<b>YOUNG CHANG CO., LTD</b>		
PC1 CONNECTOR BOARD M IDIFIED BY YLTEAM		
Size A3	Document Number REV : A VER : 1	Rev <Re Code>
Date: Monday, September 01, 2003	Sheet 2 of 3

YOUNG CHANG CO., LTD		
Title PC1 CONNECTOR BOARD MO DIFIED BY YLTEAM		
Size A3	Document Number REV : A VER : 1	Rev <Re Code>
Date: Wednesday, July 09, 2003	Sheet 3 of 3

<b>YOUNG CHANG CO., LTD.</b>		
Title	PC1 FRONT BOARD MODIFIED BY YLEEM	
Size	Document Number	Rev
Custom	REV : A VER : 1	<RevCode>
Date:	Monday, June 30, 2003	Sheet 1 of 1

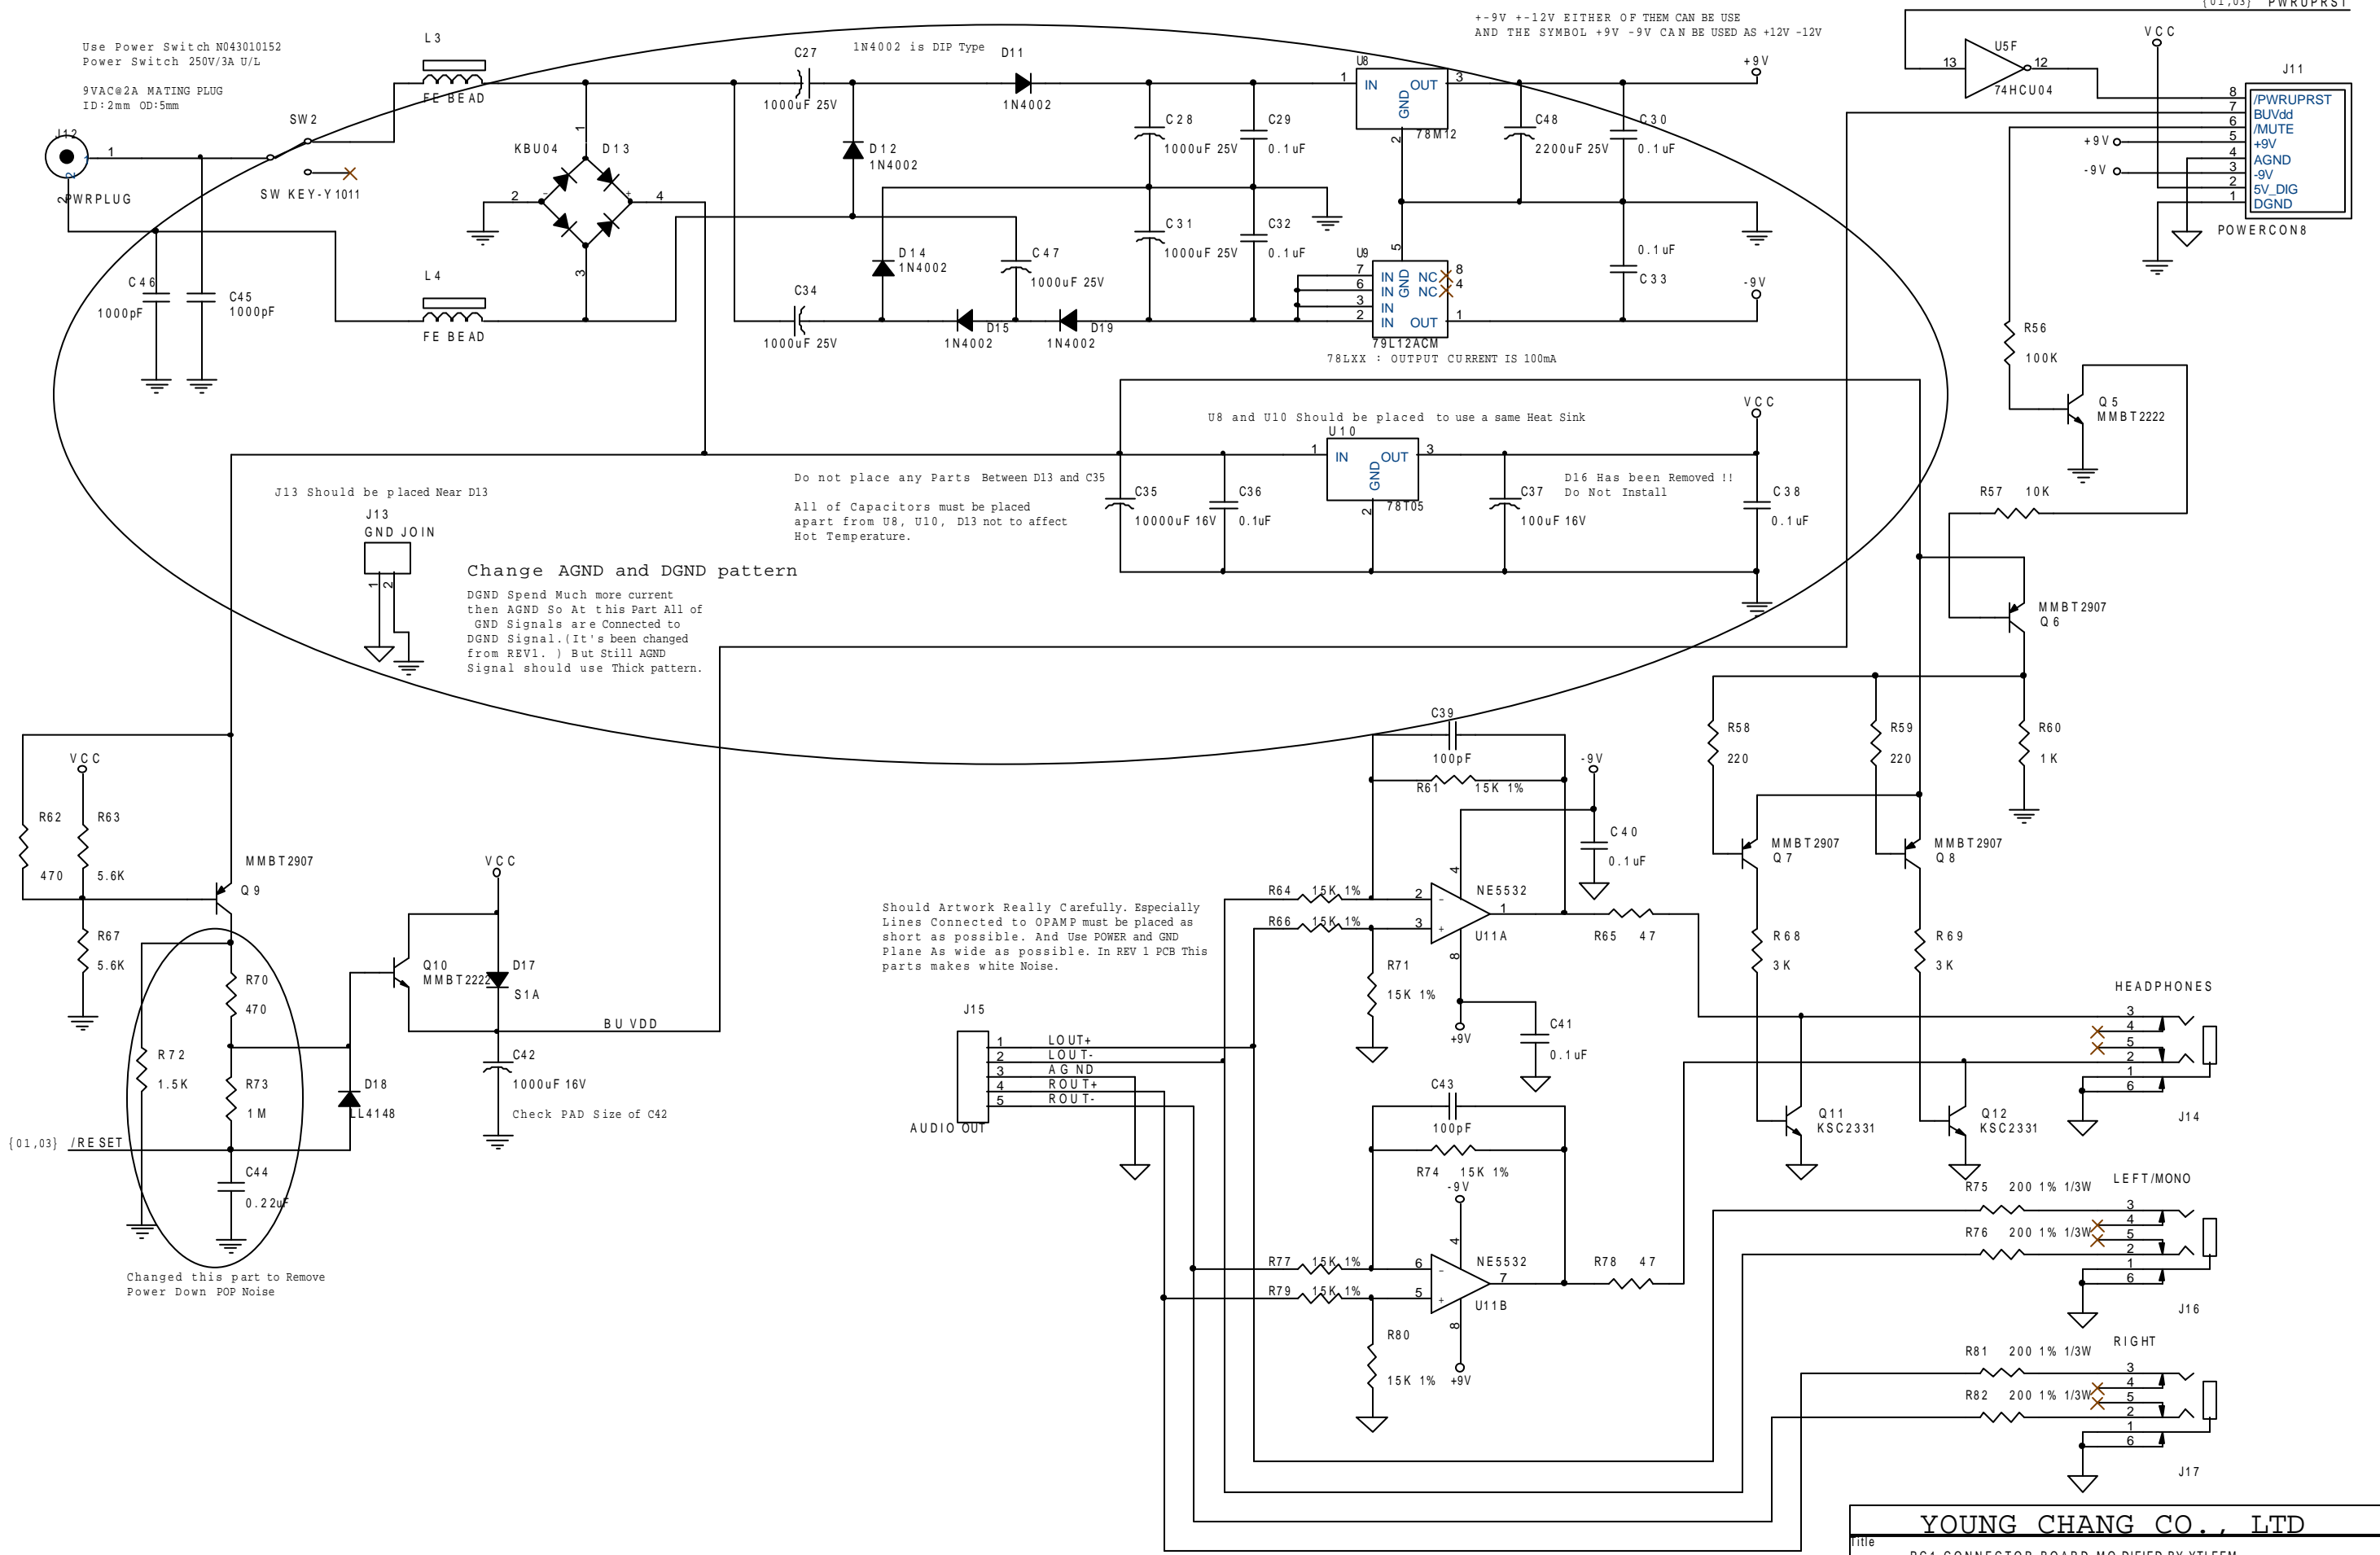
J13 Should be placed Near D13

Change AGND and DGND pattern

DGND Spend Much more current  
then AGND So At this Part All of  
GND Signals are Connected to  
DGND Signal. (It's been changed  
from REV1. ) But Still AGND  
Signal should use Thick pattern.

Do not place any Parts Between D13 and C35  
All of Capacitors must be placed  
apart from U8, U10, D13 not to affect  
Hot Temperature.

U8 and U10 Should be placed to use a same Heat Sink

D16 Has been Removed !!  
Do Not Install

Should Artwork Really Carefully. Especially  
Lines Connected to OPAMP must be placed as  
short as possible. And Use POWER and GND  
Plane As wide as possible. In REV 1 PCB This  
parts makes white Noise.

Changed this part to Remove  
Power Down POP Noise

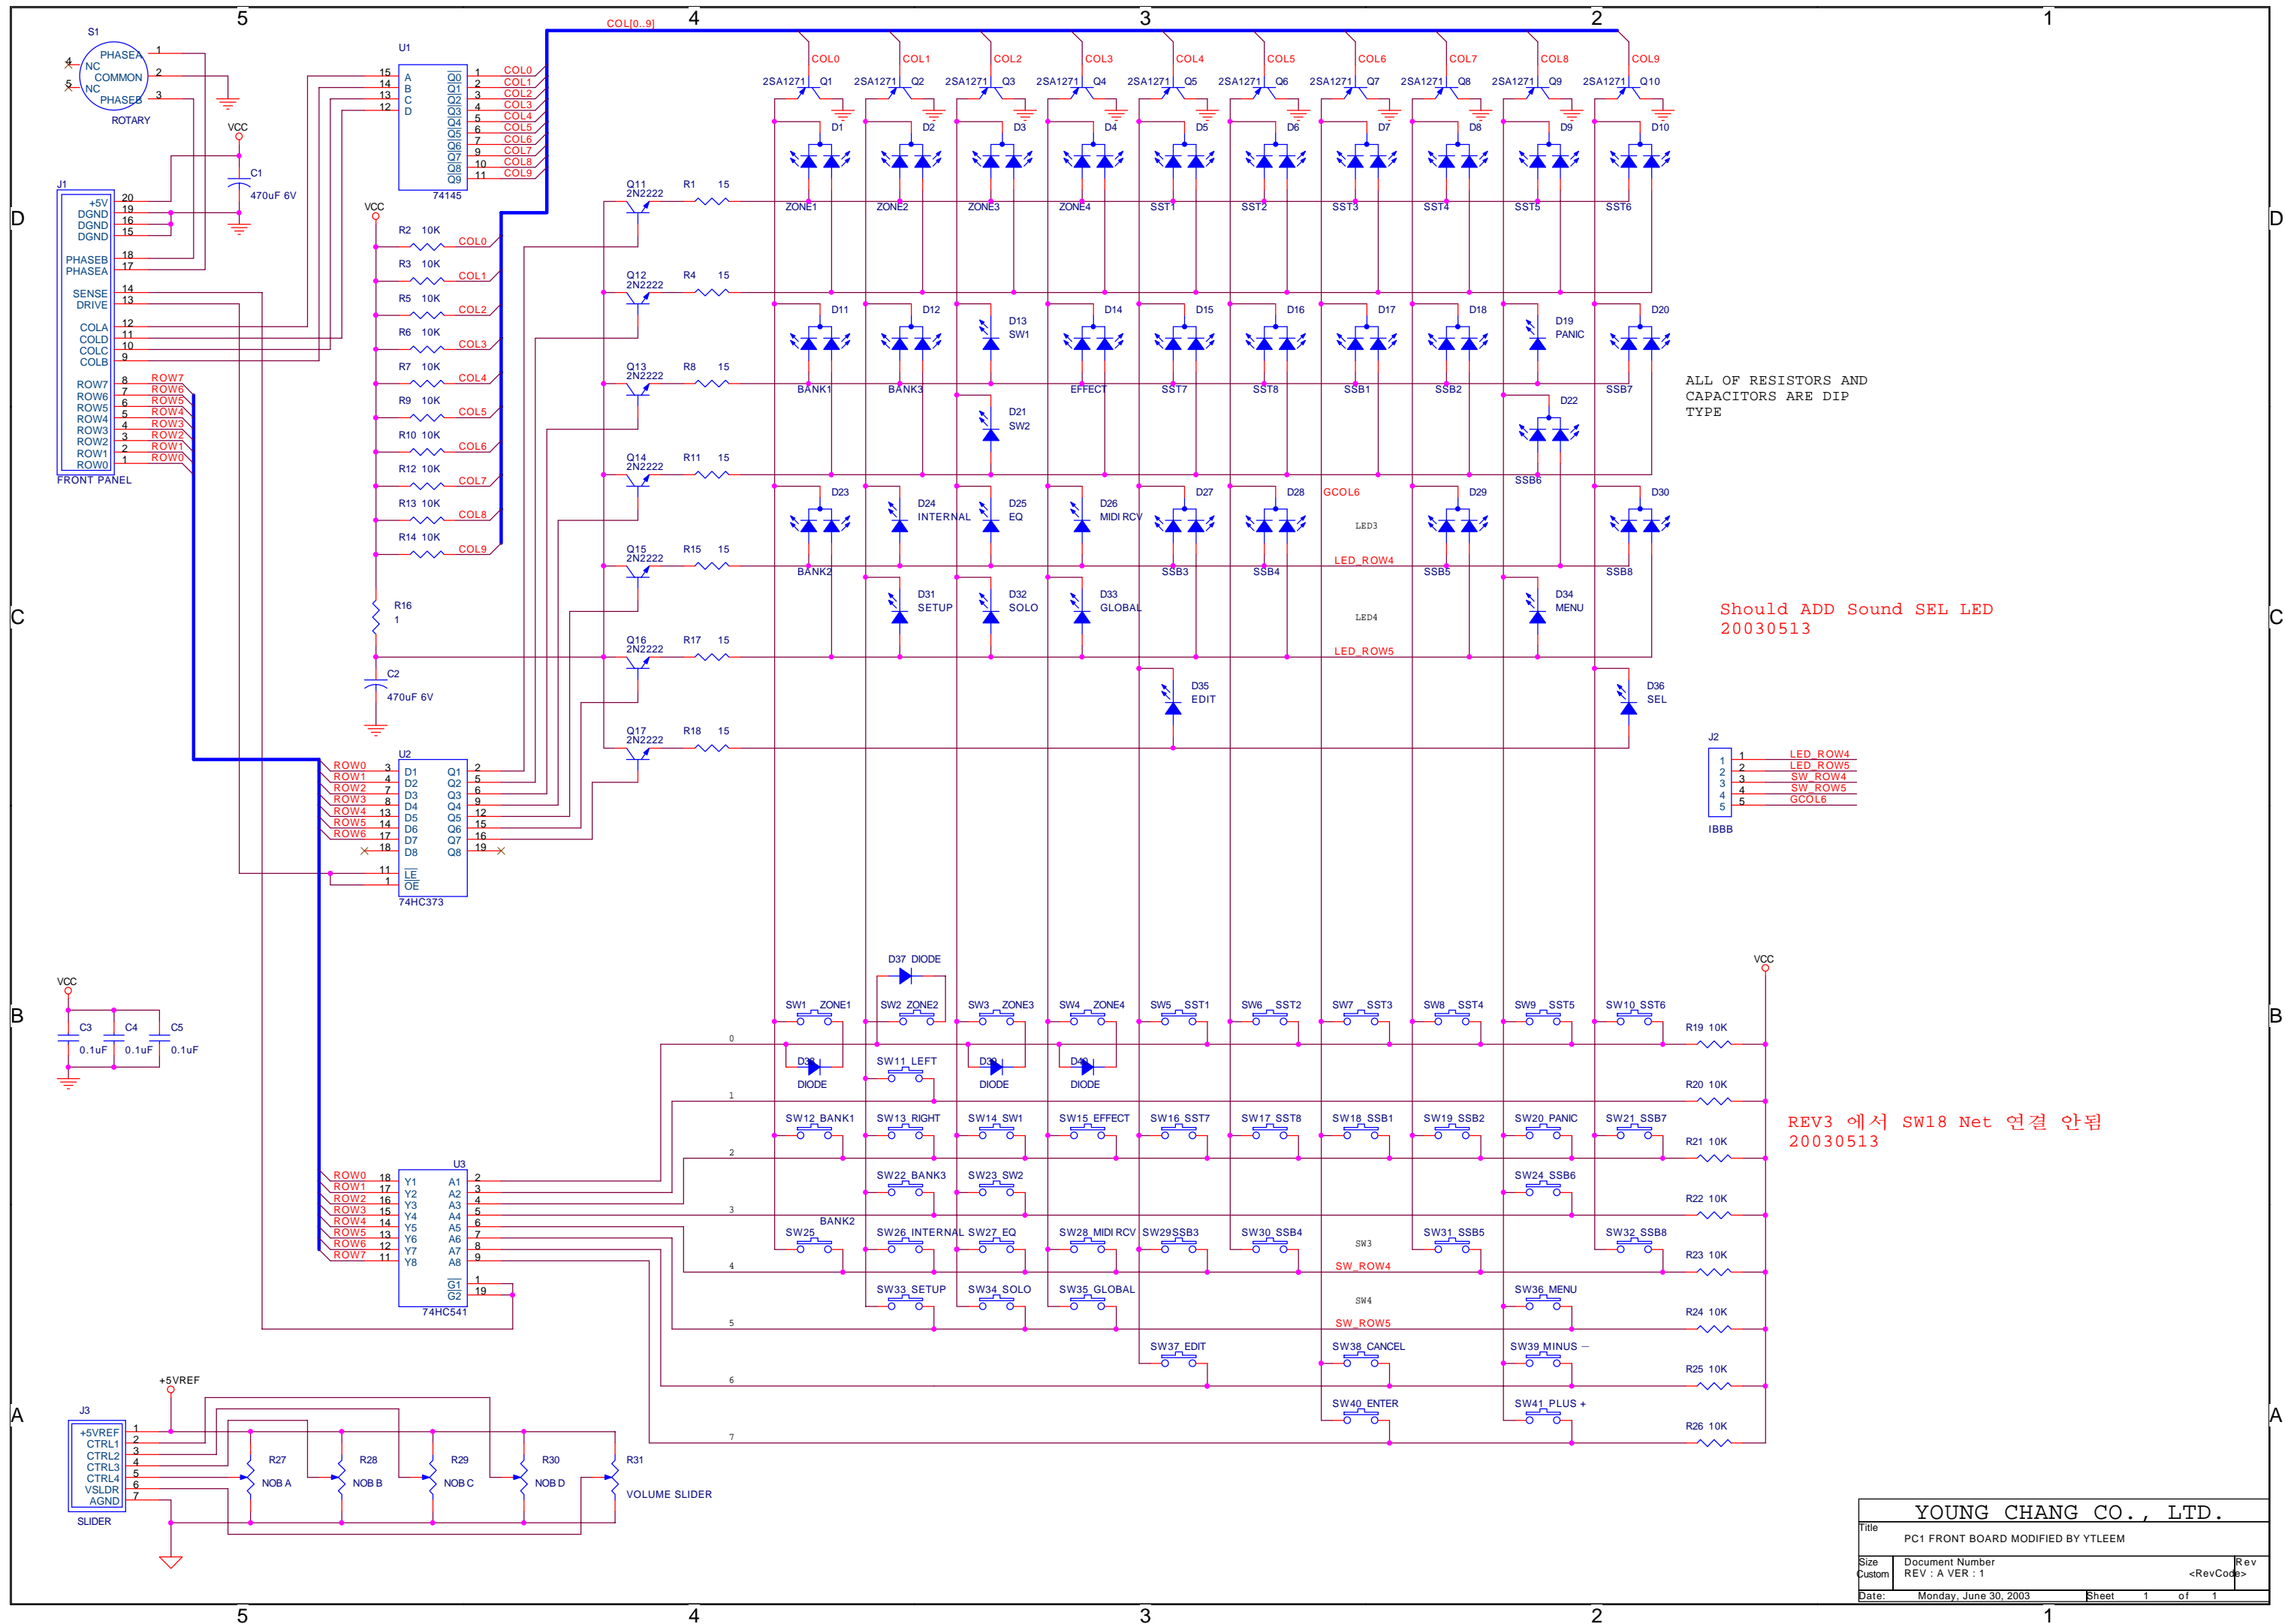
Should ADD Sound SEL LED 20030513

REV3 에서 SW18 Net 연결 안됨 20030513
